Application for a Section 5 Declaration
Development / Exempted Development

ALTERATIONS AND REFURBISHMENT/CONSERVATION WORKS TO THE EXISTING HEALTHCARE BUILDING TO ACCOMMODATE DAYCARE AND THERAPY SERVICES AND TO CONSERVE AND RESTORE CHARACTER TO THE PROTECTED STRUCTURE

PROPOSED ALTERATIONS AND REFURBISHMENT WORKS
TO ST. PATRICK'S HOSPITAL, CASHEL, CO. TIPPERARY
PROTECTED STRUCTURE NO. 22105082

Planning Reference:	S5/26/54
Applicant:	Health Service Executive
Development Address:	St. Patricks Hospital, Cahir Road, Cashel, Co. Tipperary
Proposed Development:	Alterations and refurbishment / conservation works to the existing health care building to accommodate daycare and therapy services and to conserve and restore character to the protected structure.

PLAN OF PORCH

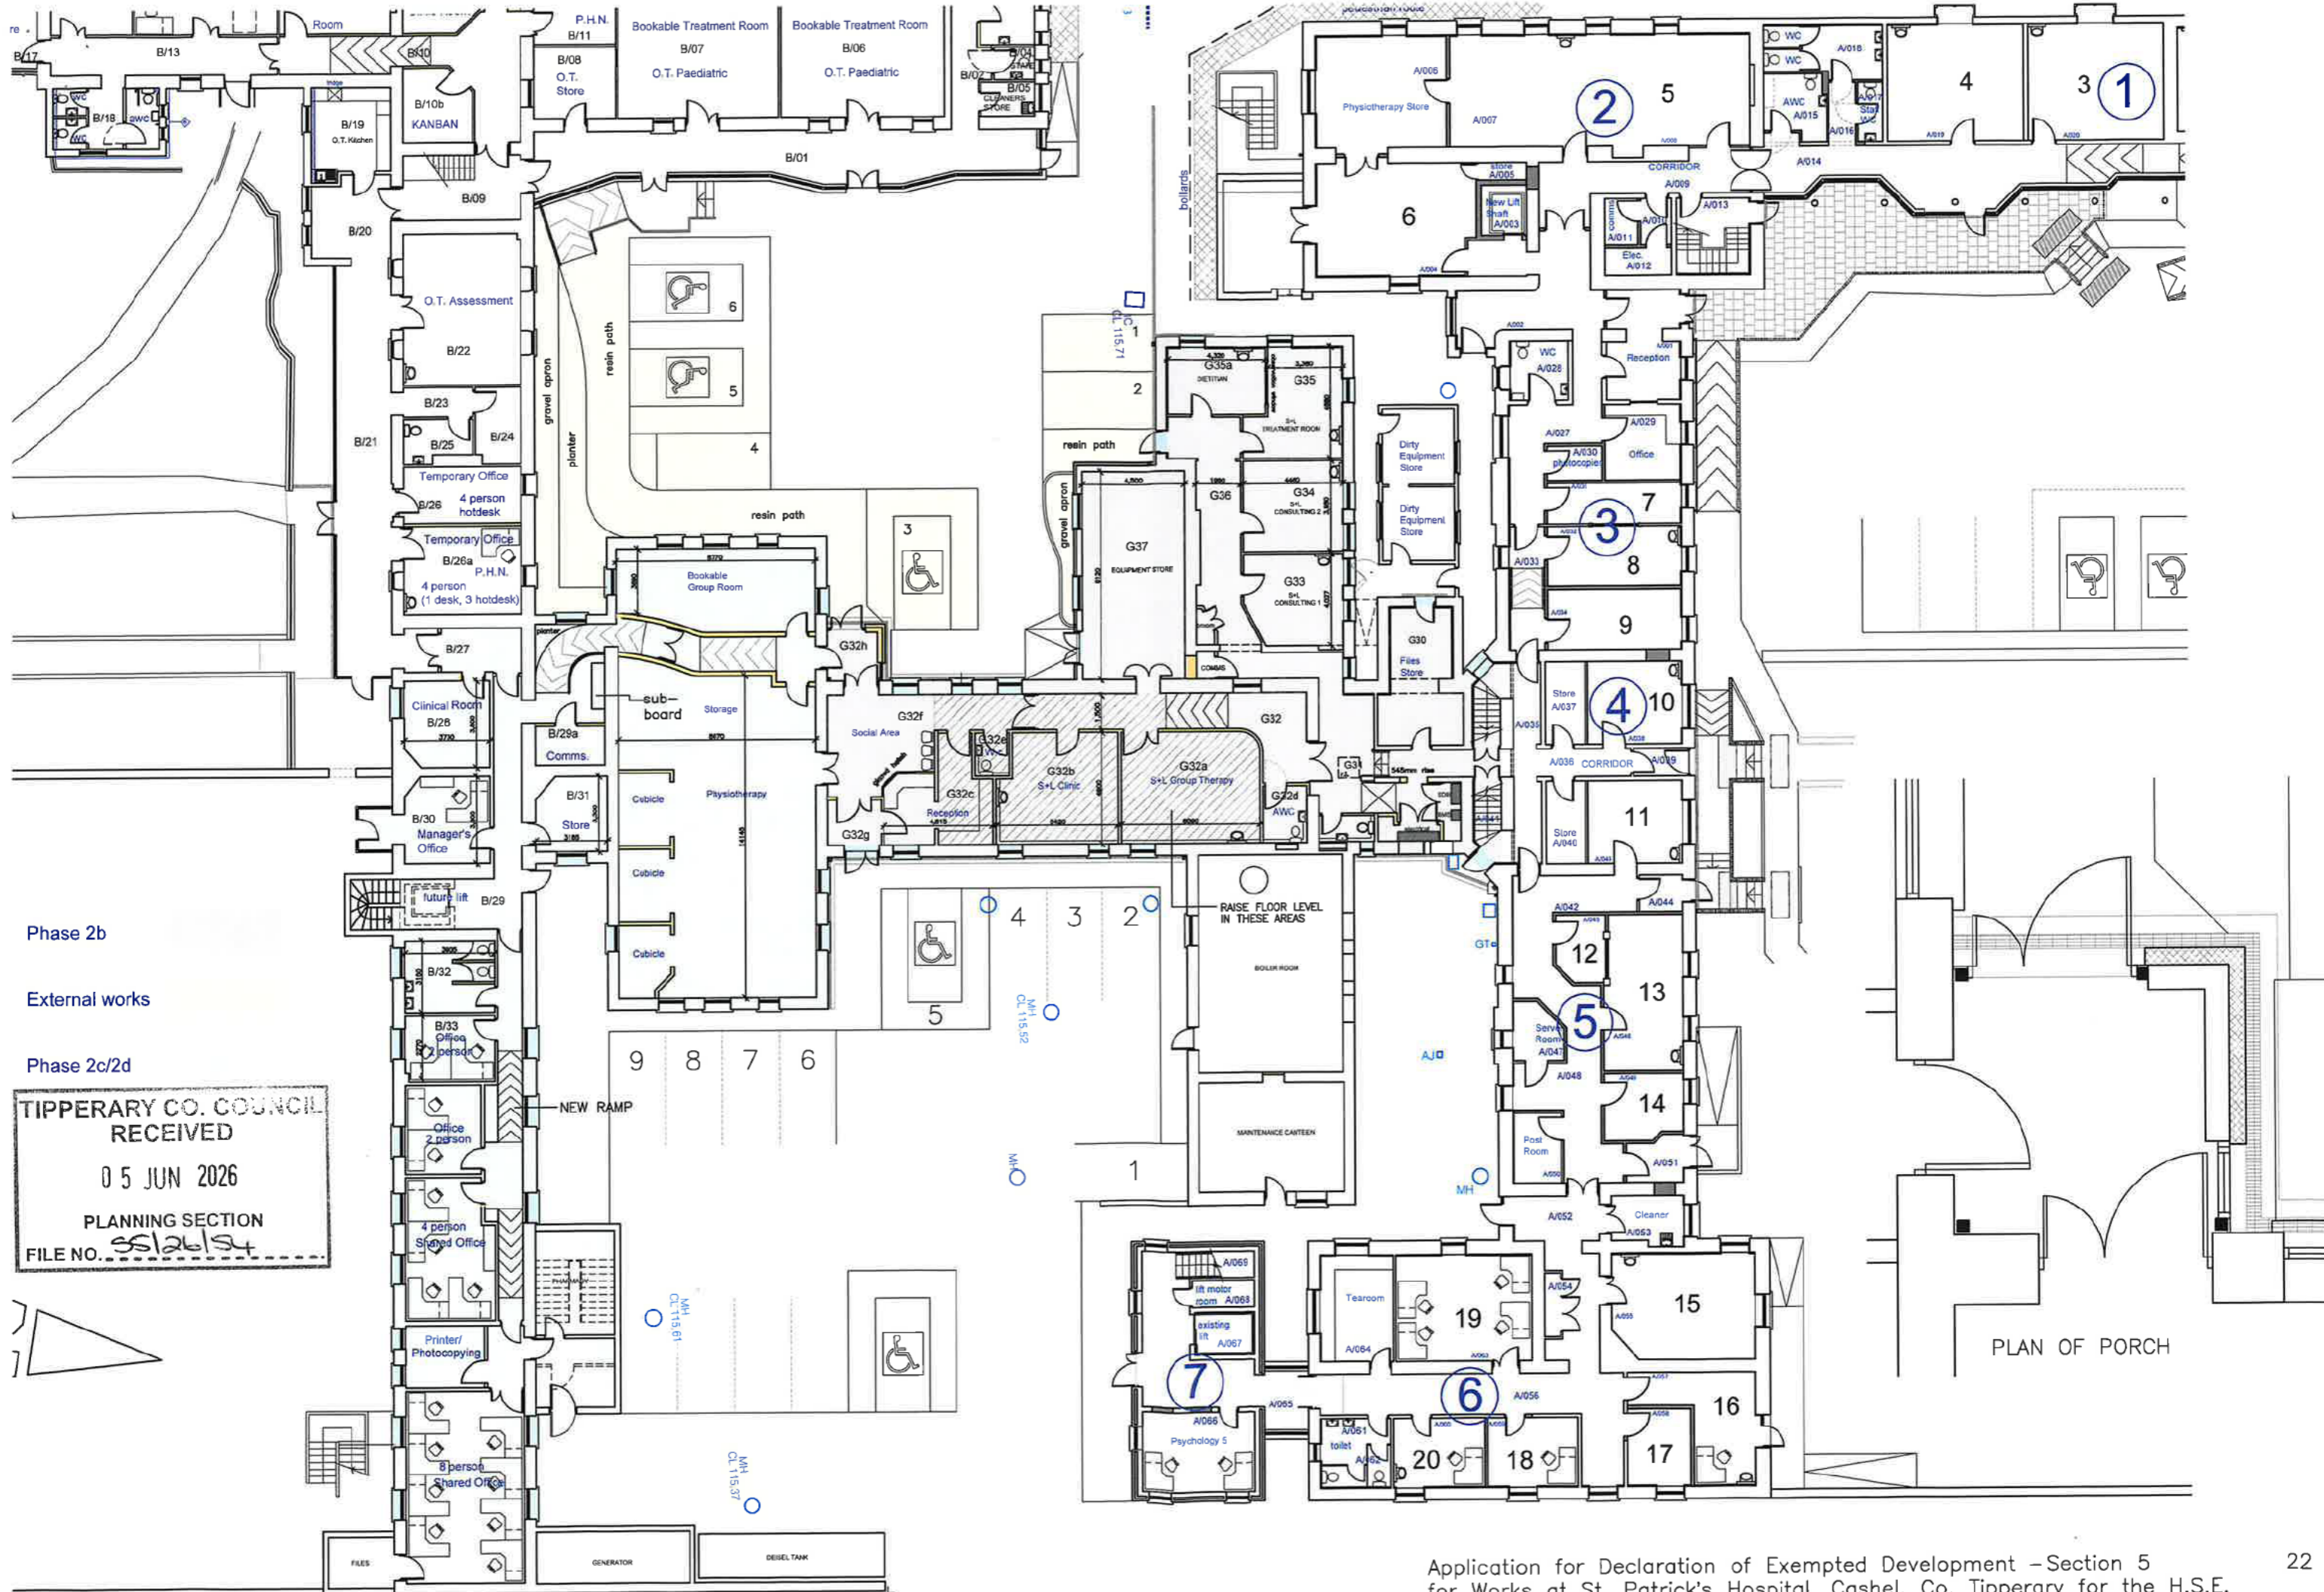
They have definitely shown good intent and the amendment of the layout of ramps shown in the FI response has reduced the number of new openings in historic masonry walls required to provide ramped access through the facility. However, the apparently ad-hoc nature of the layout design and the very open-ended scope of works to the roof, walls, windows etc. suggests that the application team has relatively limited experience of the level of work required to maintain and repair historic masonry buildings.
